Responses to property subdivision - L&I Comments

7111 GERMANTOWN ASSOCIATES

7111 GERMANTOWN AVENUE

VEGETATIVE ROOF CANOPY - CODE SUMMARY, SITE PLAN, ROOF PLAN, SECTION, ELEVATION

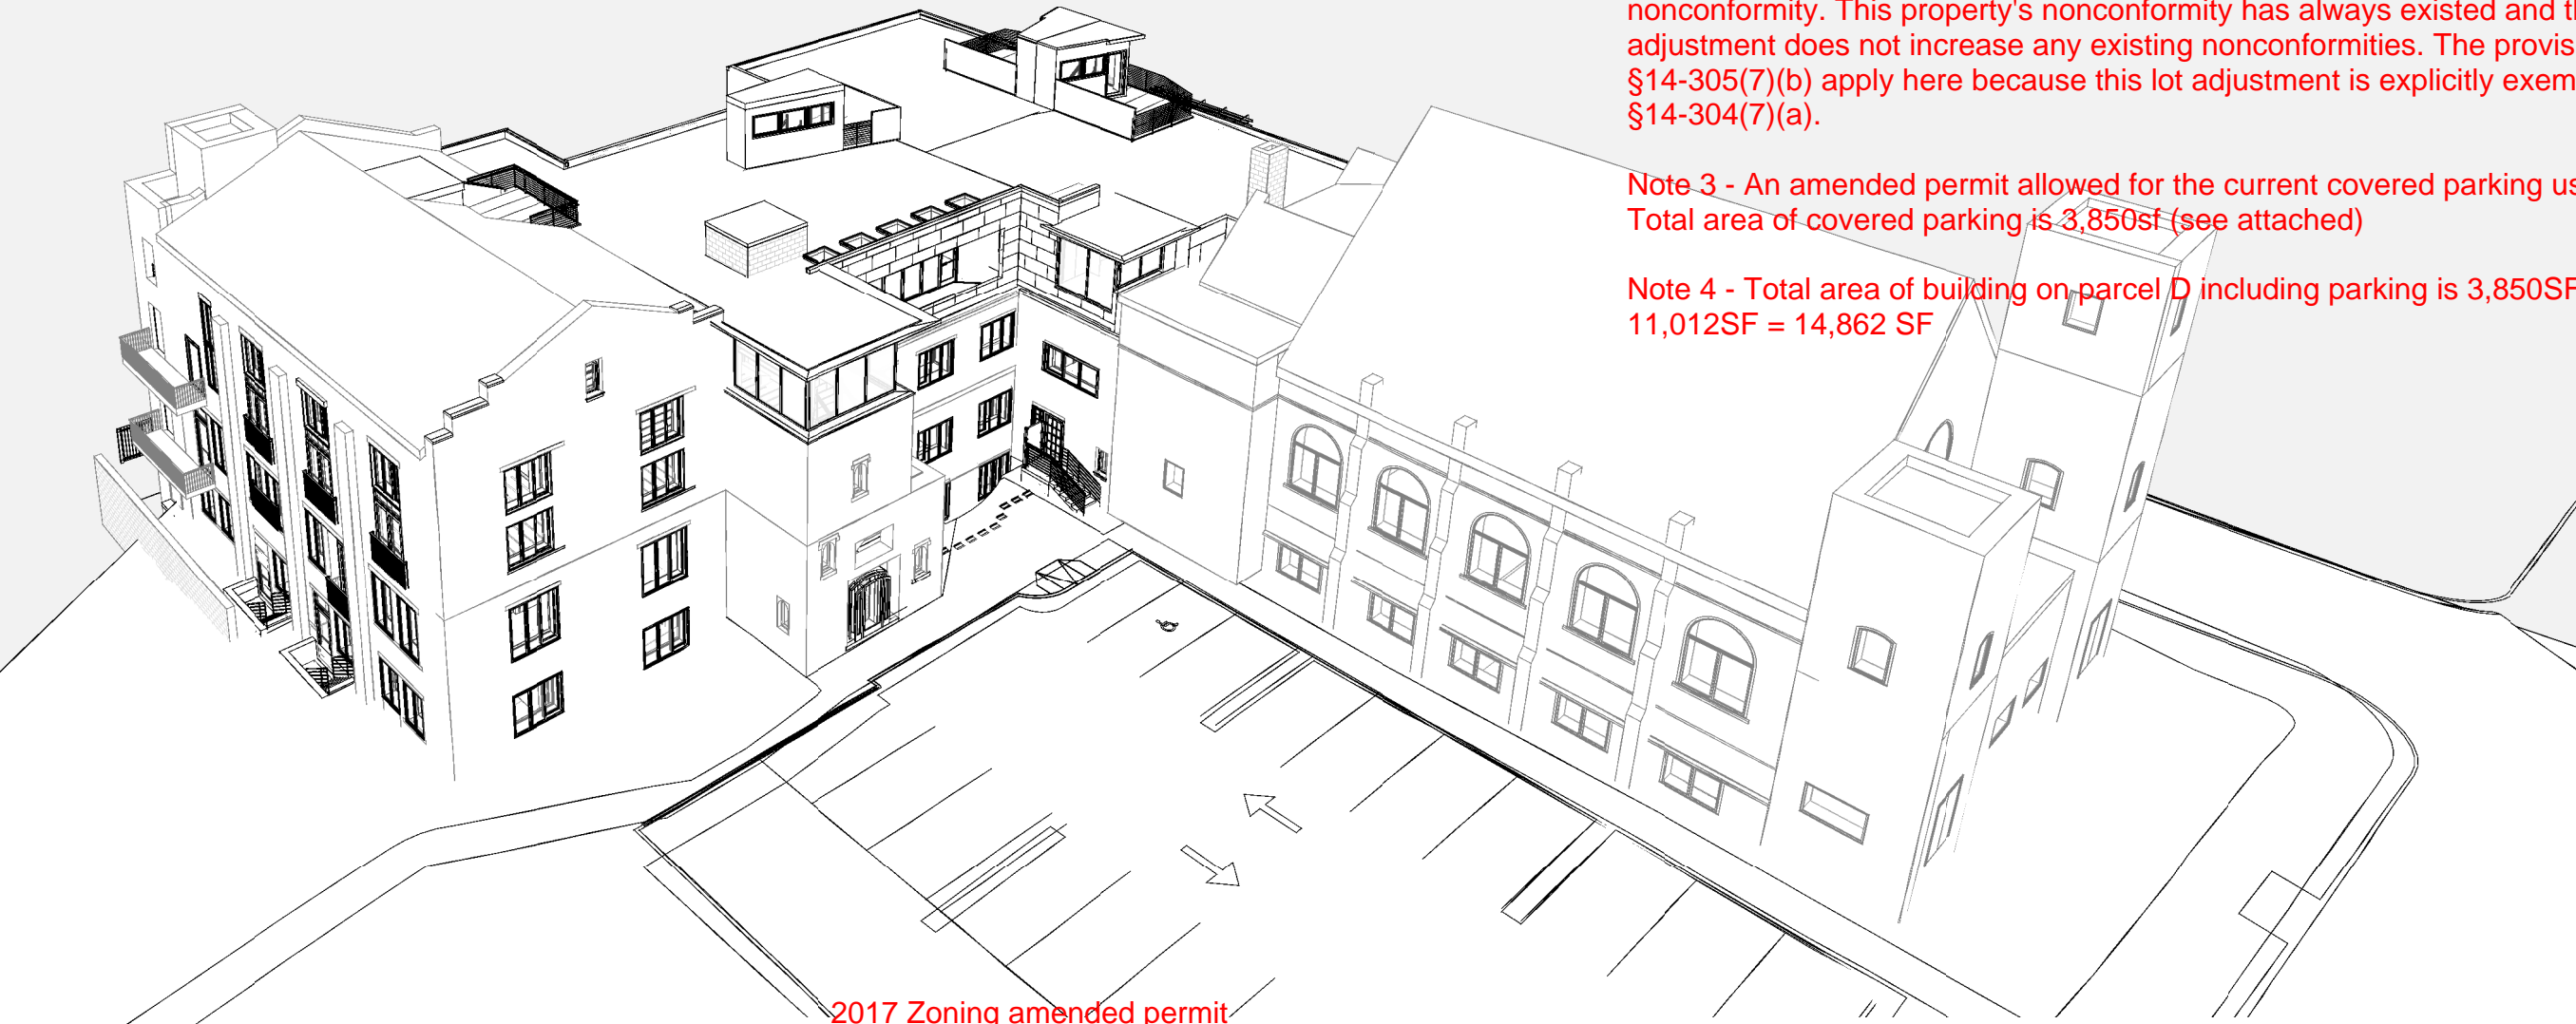
Note 3 - An amended permit allowed for the current covered parking use per Total area of covered parking is 3,850sf (see attached)

2 SITE PLAN - VEGETATIVE ROOF CANOPY
P-100 1/8" = 1'-0"

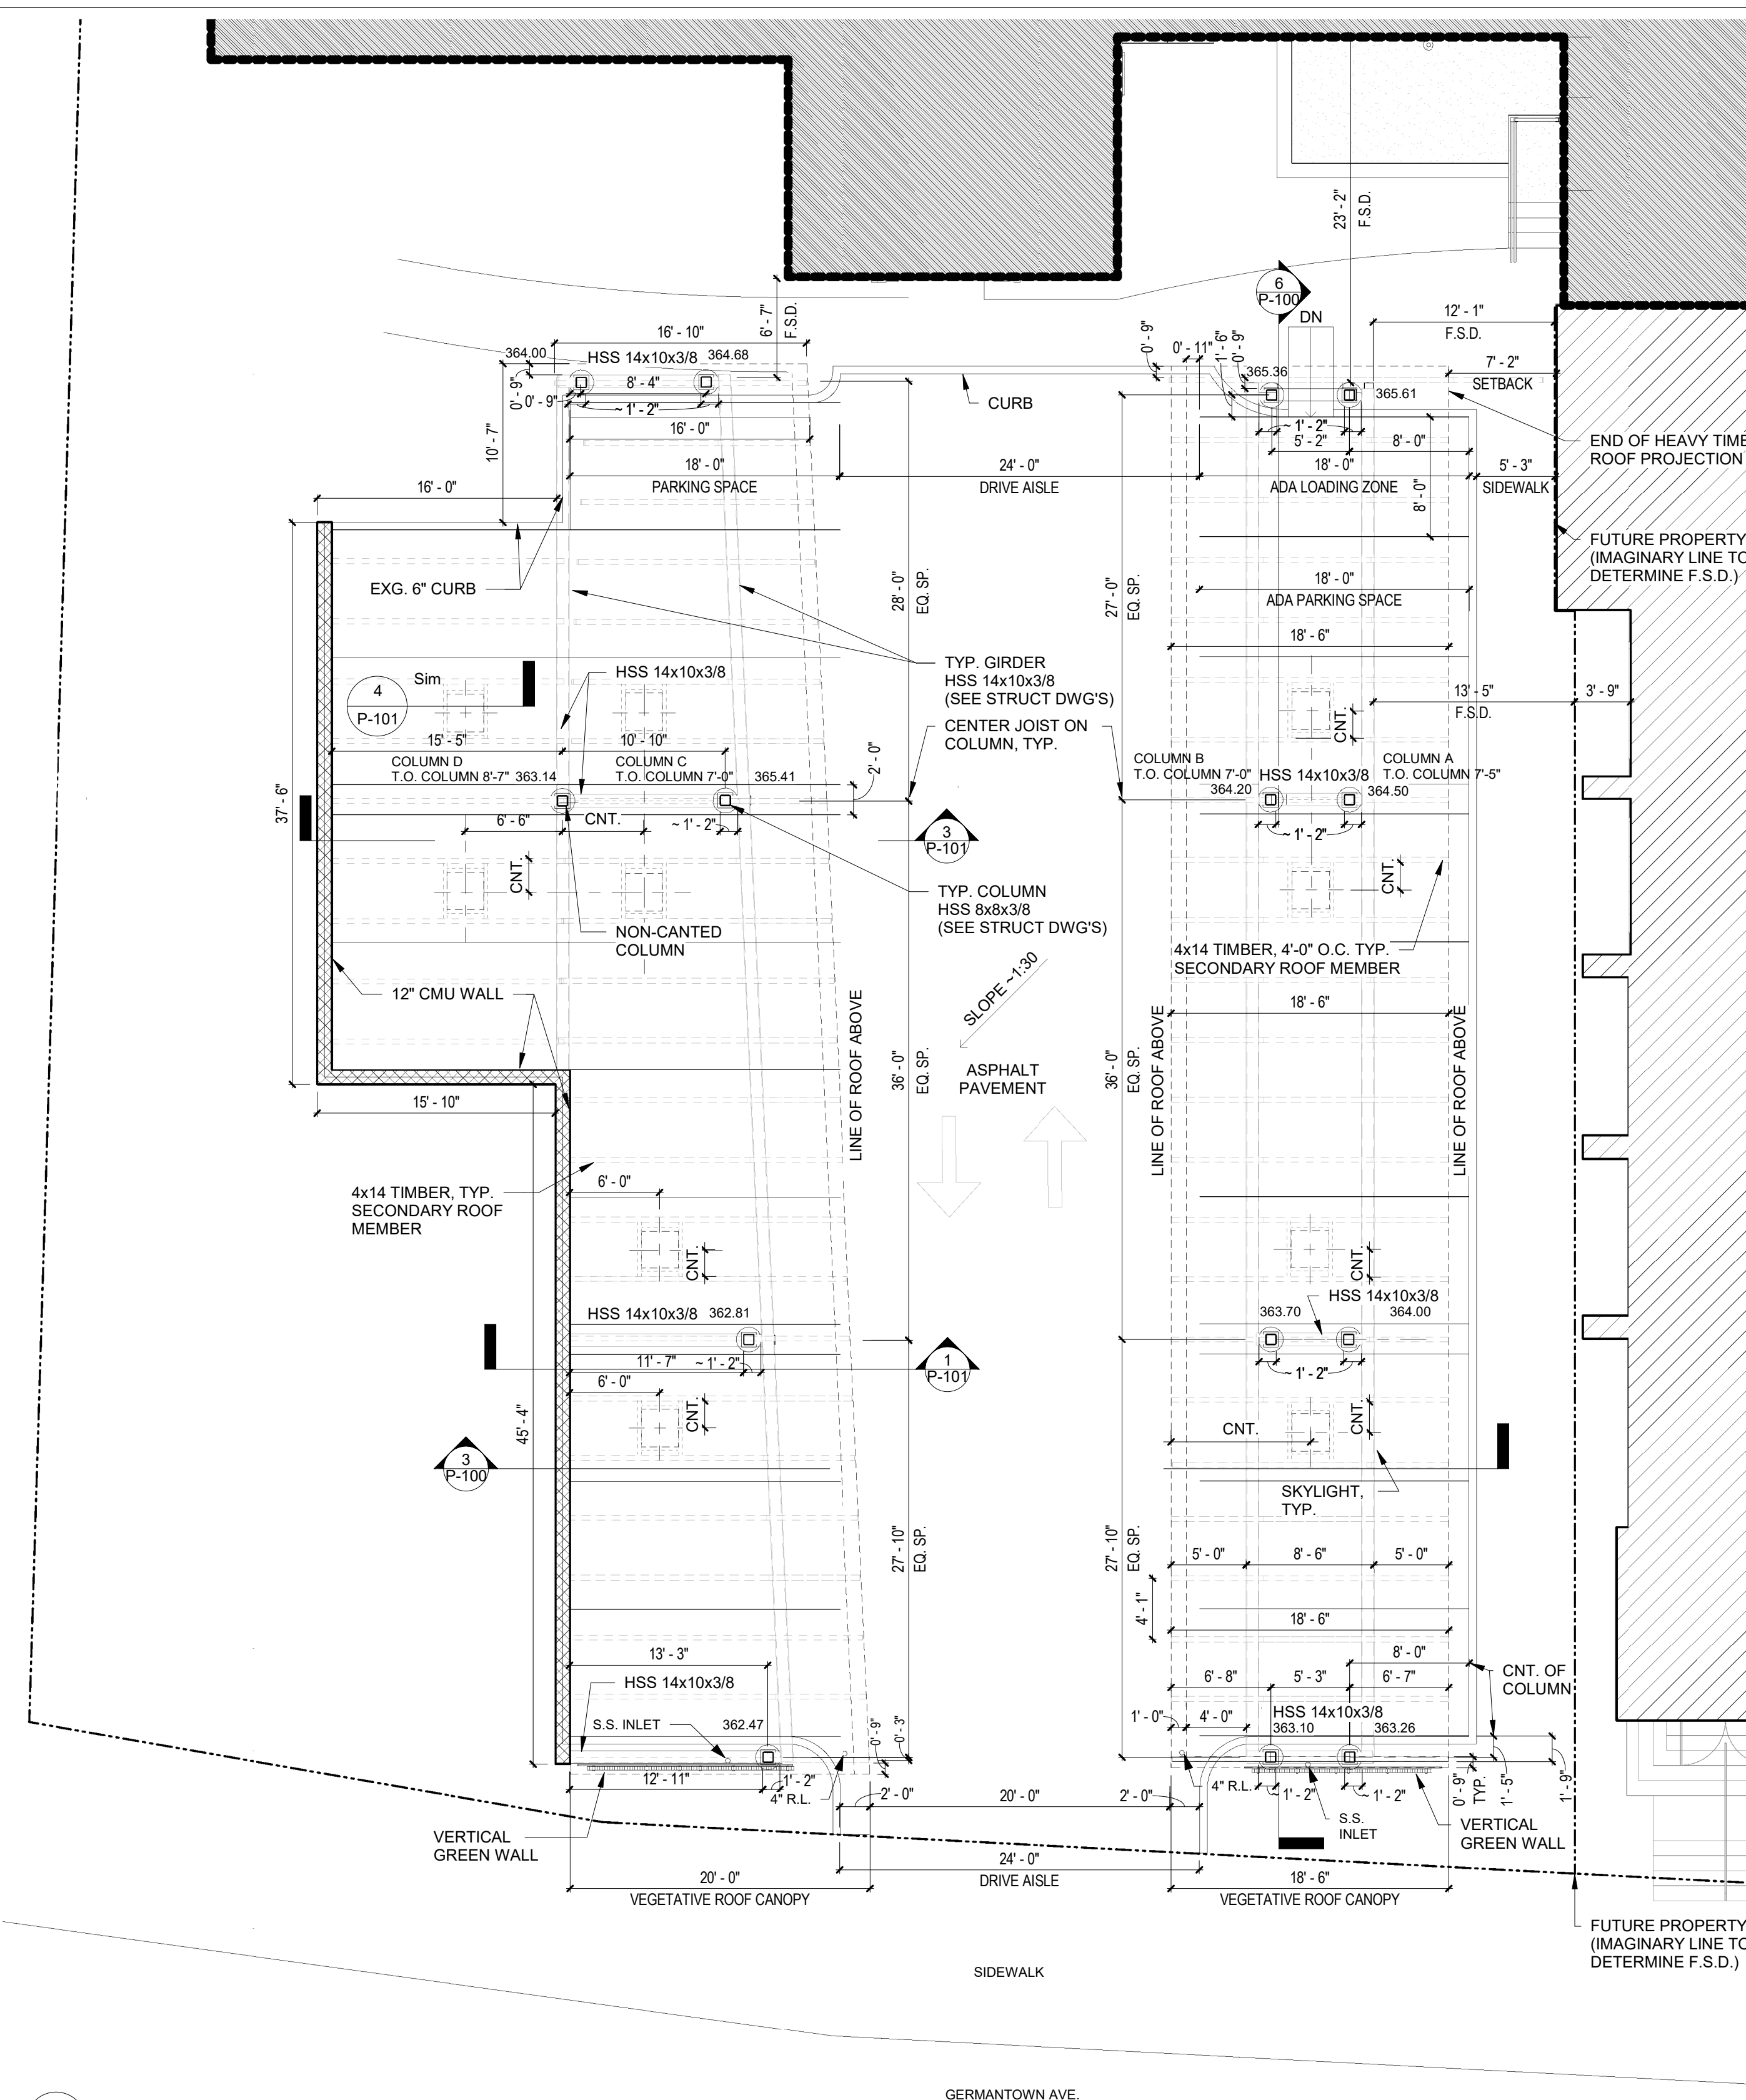
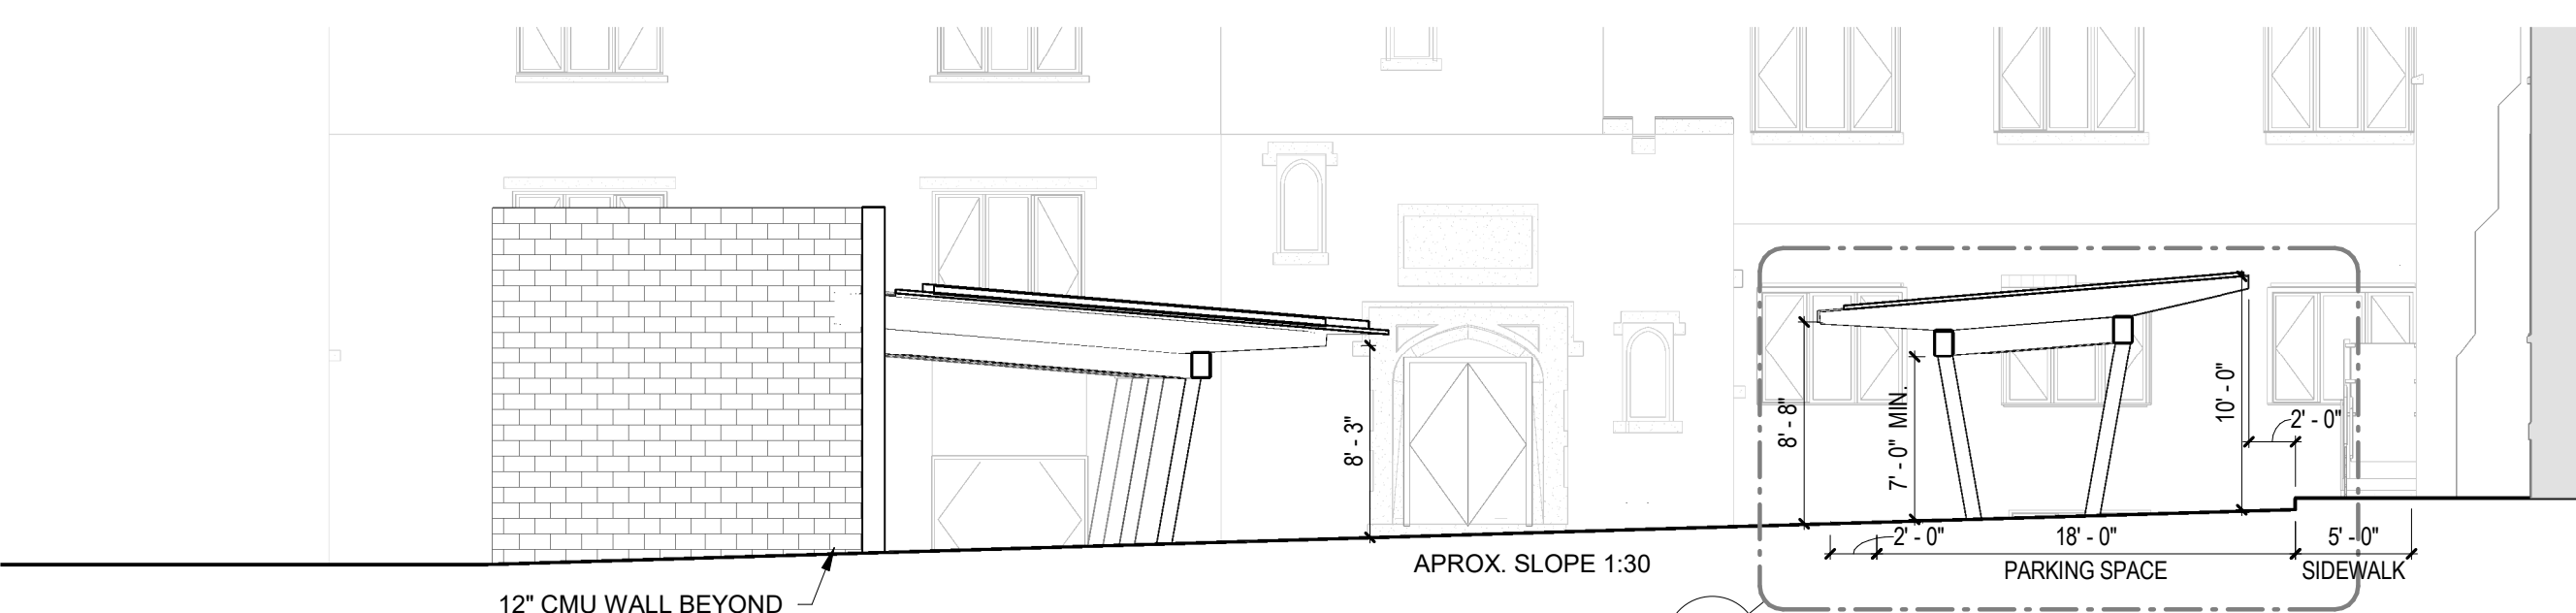
Note 4 - Total area of building on parcel D including parking is 3,850SF + 11,012SF = 14,862 SF
